# Regulation Committee

# Item Number 5: Environment Agency Response

**EXTEND THE STAFF CARPARK AND TO CREATE A MULTI-USE GAMES AREA  
WITHIN THE GROUNDS OF THE EXISTING SCHOOL AT PARKFIELD COUNTY  
PRIMARY SCHOOL, PARKFIELD ROAD, TAUNTON**

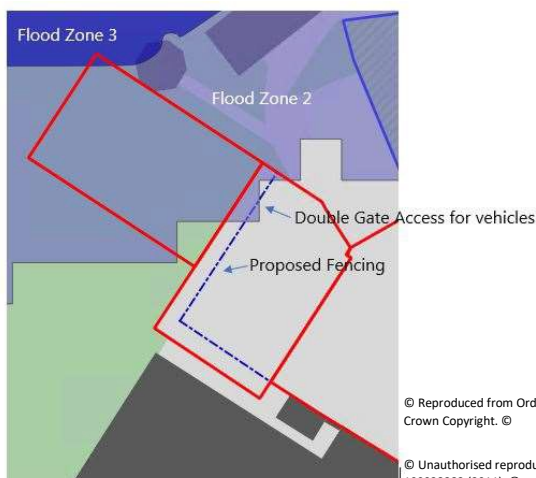
Which is can confirm the applicant does not wish to raise any ground surfaces and I am also recommending that no fences or permanent structures shall be in place on the Muga pitch, as to not impede access in an emergency. However, The applicant is proposing to install a fence between the car-park and the MUGA pitch as mentioned in the FRA, to shield the children from vehicles and to protect the vehicles from balls etc. But looking on our GIS system, this proposed fence does slightly impede on flood zone 2, as the image attached, shows:

Please could you let me know your stance on this, and whether you consider this to be acceptable or not? I can confirm that this is the only fencing proposed and recommended, and this will include double gated access for vehicles in an emergency.

After reviewing these details and as the fence is running along the boundary between Flood Zones 1 and 2 and not cutting across flood zone 2, we will not have any issue with this route.

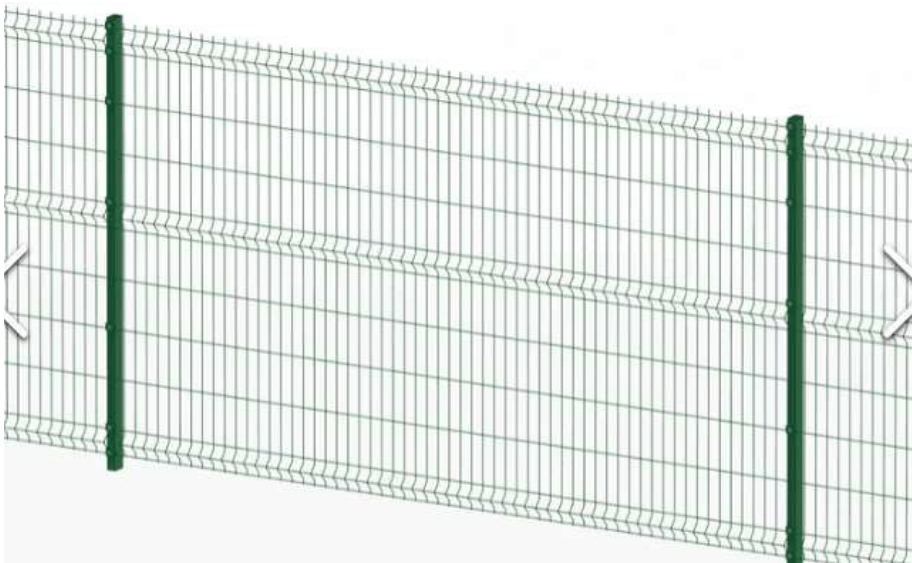
As previously requested, below are the details of the proposed fencing and double gate access that is to infringe on the edge of flood zone 2 for your information.

I am recommending that your original condition which reads "There shall be no ground raising and no permanent or temporary fencing located within Flood Zones 2 and 3, to ensure no increased risk of flooding." Now be slightly amended to read "**Other than hereby approved**, there shall be no ground raising and no permanent or temporary fencing located within Flood Zones 2 and 3 to ensure no increased risk of flooding." to allow the provision of this fencing and gate, which you mentioned in your updated response that you have no issue with.

The fencing will be 2.0m high 358 D Mesh Security fencing with a twin mesh double leaf gate 2.0m high x 4.0m wide.

The gate and fencing are shown in green below. However, we would like the fencing and gate to be in blue (RAL 5010).

I can confirm that the amendments as detailed within your email below would be acceptable. Many thanks
